REPORT ON THE REVIEW OF THE
DIESEL GENERATOR BUILDING AT MIDLAND

OCTOBER, 1983

Structural Engineering Section B
Structural and Geotechnical Engineering Branch
Division of Engineering, ONRR

FIGURE 2

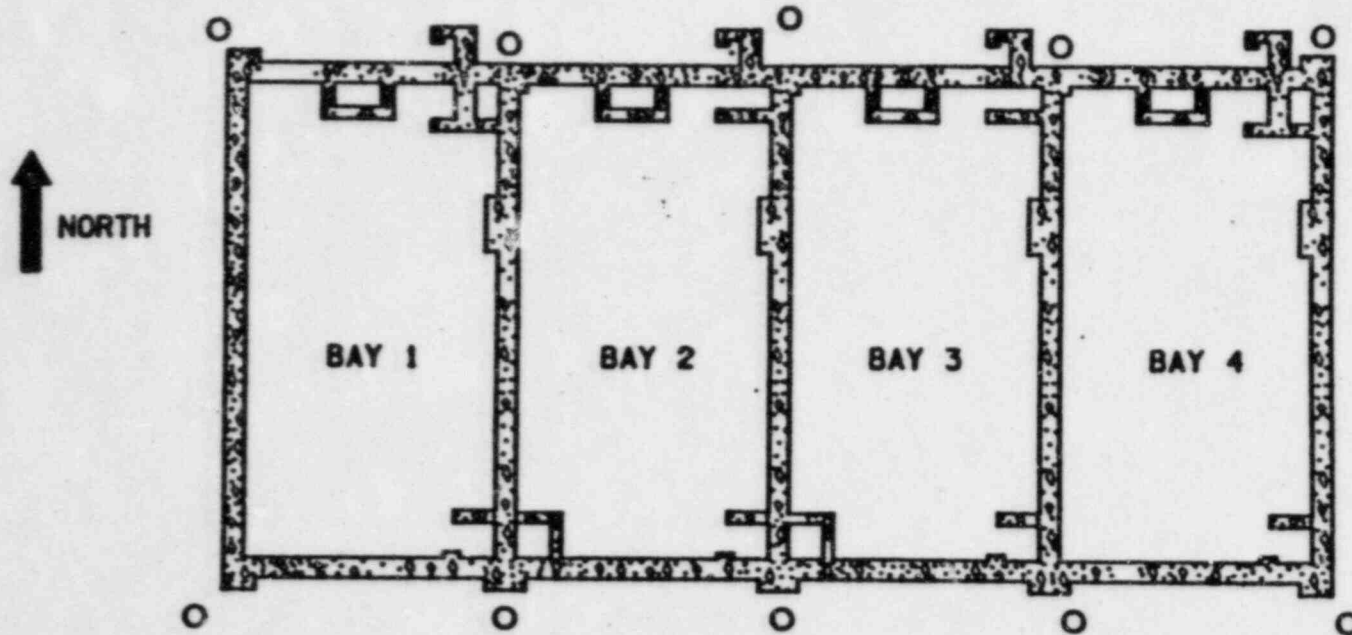
3. Inconsistencies in the documentation of the settlement history needs to be resolved. For example, the Midland Units 1 and 2 Executive Summary dated August, 1983 states that for the July 1978 period, the maximum settlements recorded were 3.5 inches while Figure ES-14 of the same document indicates a maximum of 1.99 inches for the same period.

FIGURE 4

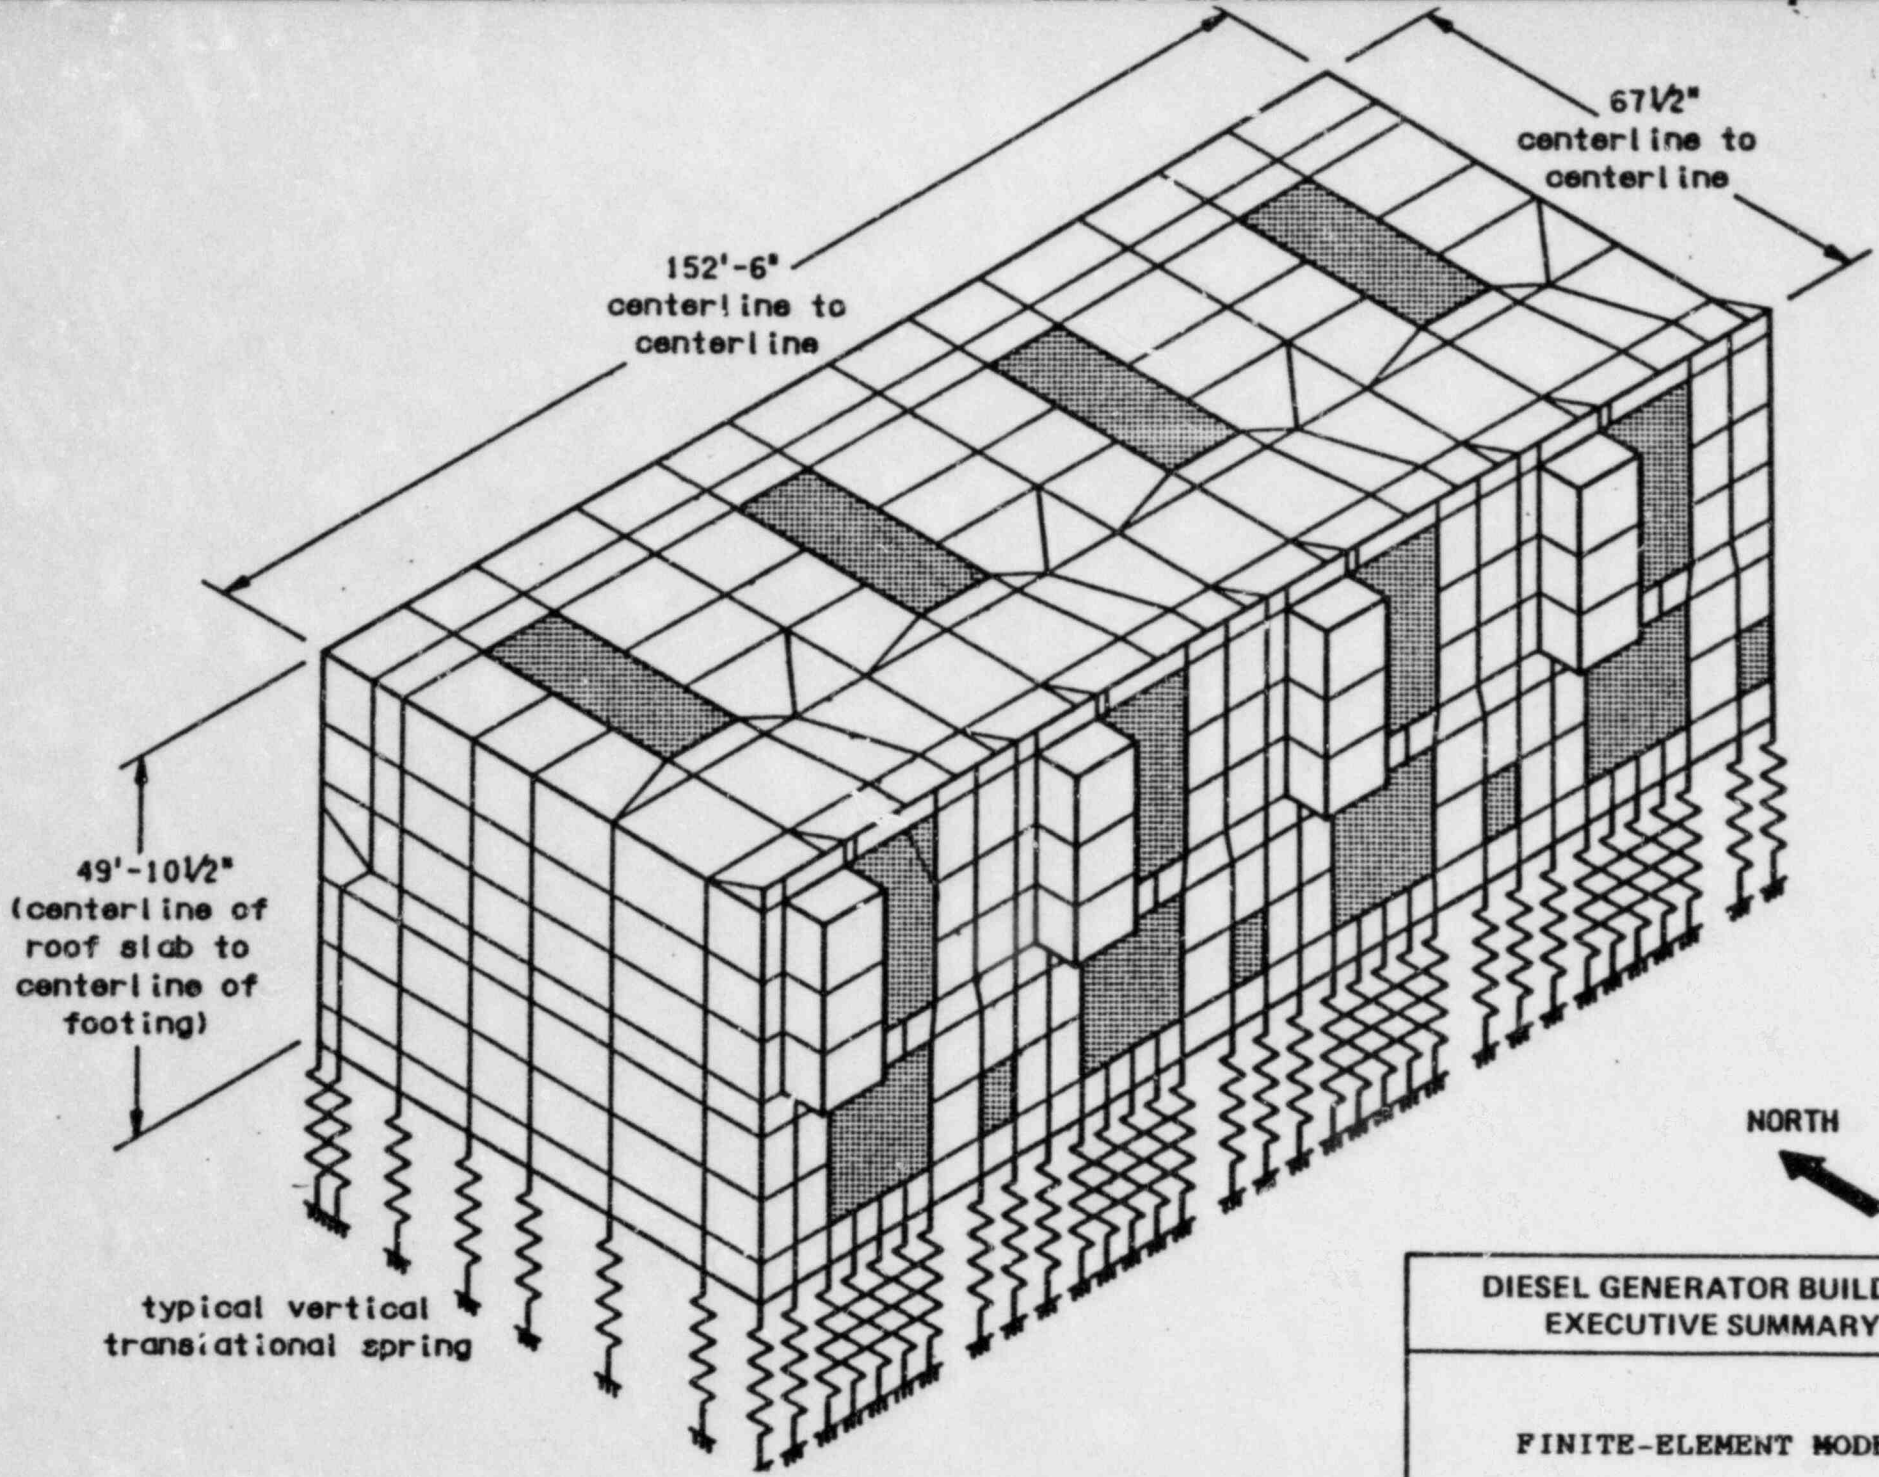
The settlement measurements which are available correspond to those in the later stages of DGB construction, that is, when the as-built portions of the DGB are relatively rigid. The Applicant performed three separate finite element analyses for which measured and/or predicted settlement values are available. The measured and/or predicted settlement values are used as data points in linearizing the settlement. The differences between the measured/predicted settlement values and the resulting linearized values have been discounted as survey inaccuracies. This is basically equivalent to assuming that the north and south walls underwent rigid body motions. The computed stresses from this model are due to racking only. The stresses obtained in the process of linearizing the settlements, therefore, do not represent the actual settlement stresses.
